**Marion County
Board of County Commissioners**

**PLANNING & ZONING SECTION
STAFF REPORT**

P&ZC Date: 08/25/2025	BCC Date: 9/15/2025
Case Number	250907ZC
CDP-AR	32957
Type of Case	Rezone from General Agriculture (A-1) and Mixed Family Dwelling (R-4) to Planned Unit Development (PUD)
Owner	Homestead Villas (Nate Chambers, Mgr.), Martin, Starlin J. & Williams Family Trust
Applicant/Agent(s)	Fred N. Roberts Jr., Esq.
Street Address / Site Location	550 NW 73 rd Avenue (Only One Address Available)
Parcel Number	23303-002-00, 23303-000-04, 23204-002-00
Property Size	±12.77 acres
Future Land Use	Low Residential (LR)
Zoning Classification	Single-Family Dwelling (R-1)
Overlay Zone/Scenic Area	Inside of Urban Growth Boundary (UGB), Secondary Springs Protection Overlay Zone (SSPOZ)
Staff Recommendation	APPROVAL
P&ZC Recommendation	TBD
Project Planner	Kenneth odom
Historic/Related Case(s)	Companion Small Scale Land Use Amendment: 25-S12: Low Residential (LR) to Medium Residential (MR)

Figure 7
Homestead Villas Site Plan

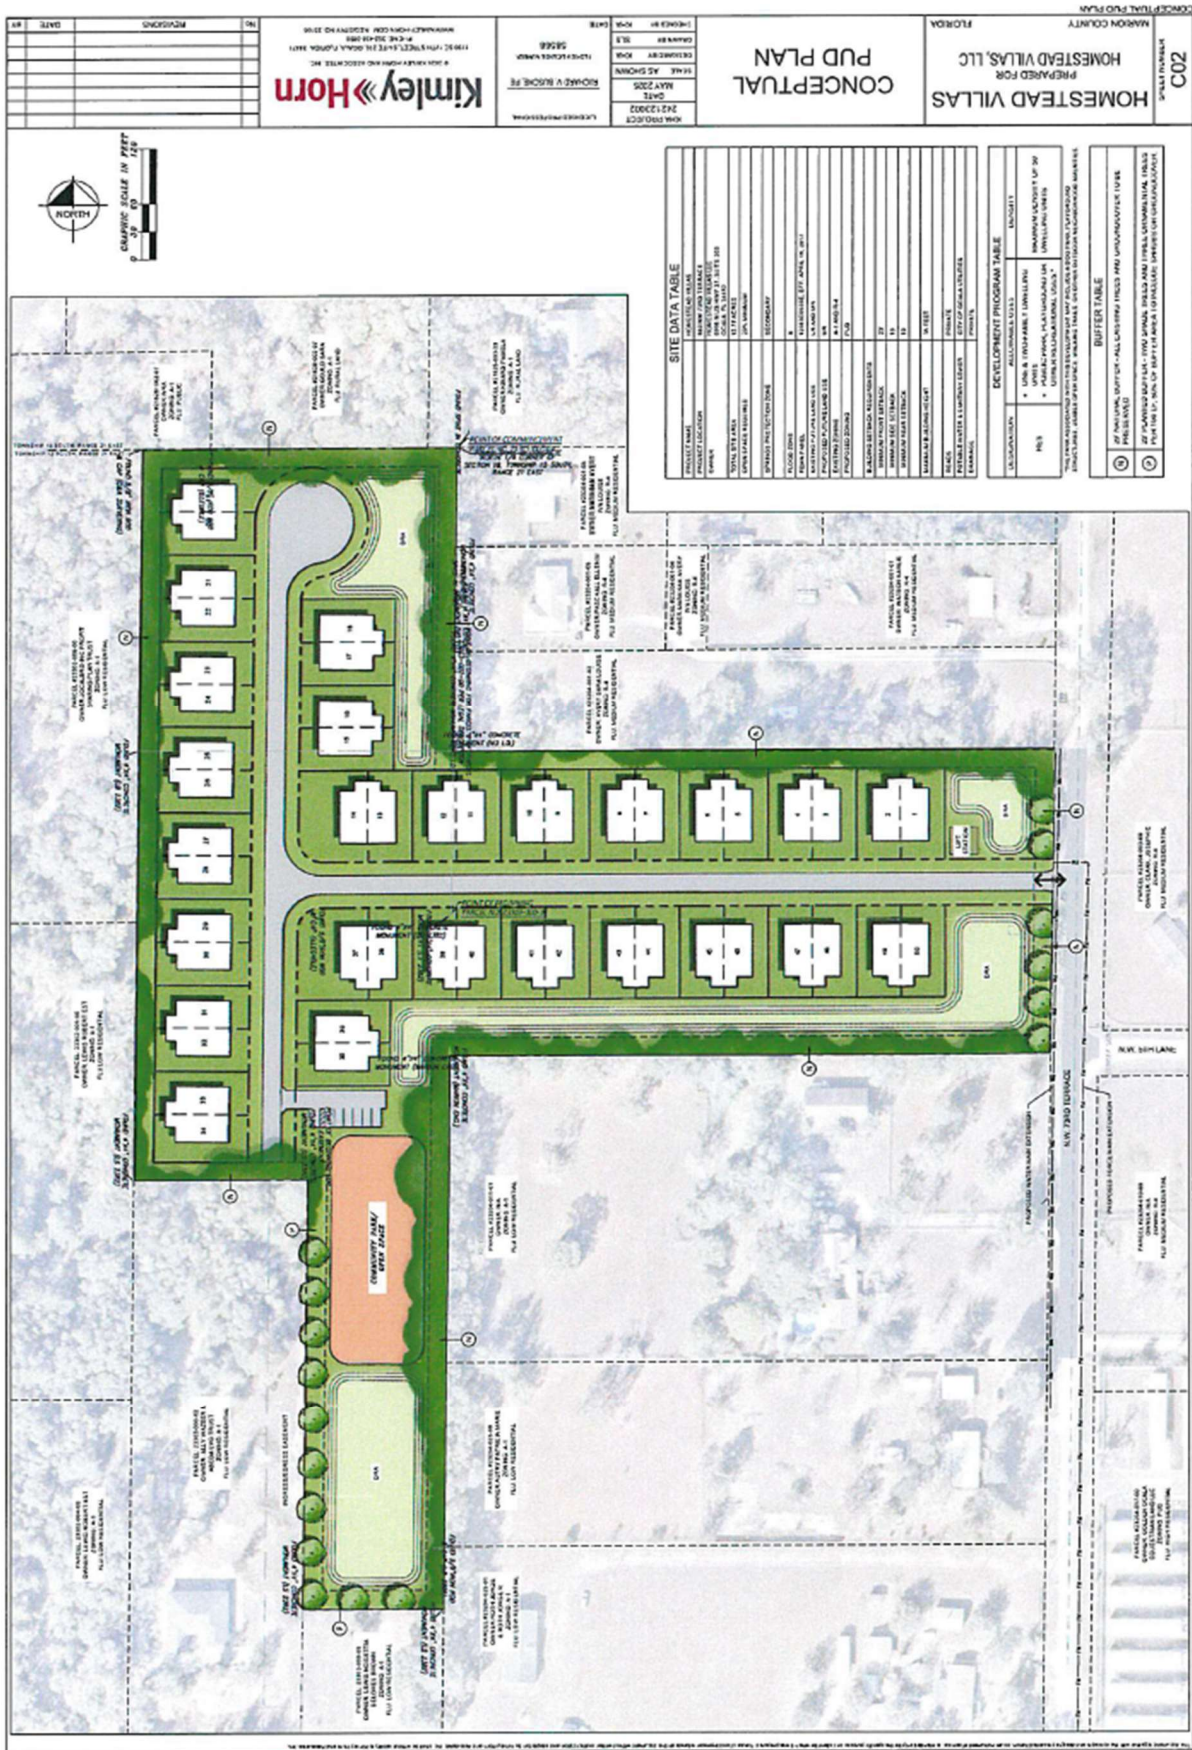
The plan proposed includes twenty-five duplexes, for a total of fifty residential units. The maximum building height provided would be 35' with a required minimum 30' separation between the buildings.

Table 3 summarizes the PUD's proposed and staff's recommended buffers for the PUD. Maps Attachment Page 8 includes buffer diagrams for the PUD's proposed buffering types and labels each of the property boundary lines with the buffer type, minus a three or four-board fence, which was discussed with the applicant during the time of the site visit.

plan provided currently includes no stormwater facilities on-site. Thus, the application is **not consistent** with SE Policy 1.1.5.

Analysis: The PUD plan states a minimum of 20% open space will be provided, but does not give detailed figures or list the areas being designated for open space on the site plan. The application is currently **is consistent** with this section of the LDC as there are no figures provided to confirm the minimum open space requirement.

Analysis: Due to completeness and sufficiency issues, staff would not consider this application to be a true PUD Master Plan. As such, staff recommends that the true final PUD development plan be required to come back before the Board of County Commissioners for a final master plan approval if this application is heard and approved by the board.

6. NW 73rd Terrace will be paved from the existing pavement to the site entrance. NW 73rd Terrace extension shall be designed, constructed, and paved to County specifications; a related offsite improvement plan is required.

7. The DRAs will be required to hold the total stormwater runoff volume generated from the 100-year, 24-hour storm event, with no off-site discharge.
8. PUD site must comply with the County's LDC lighting standards that require lighting to be shielded so as not to cast direct lighting off-site, and a photometric plan must be provided during major site plan review to ensure no negative impacts to neighboring parcels.

9. The PUD must meet the LDC requirement of a minimum of 20% improved open space.
10. The final PUD master plan must be brought back and heard by the Board of County Commissioners for final approval unless that Board deems it to be unnecessary.
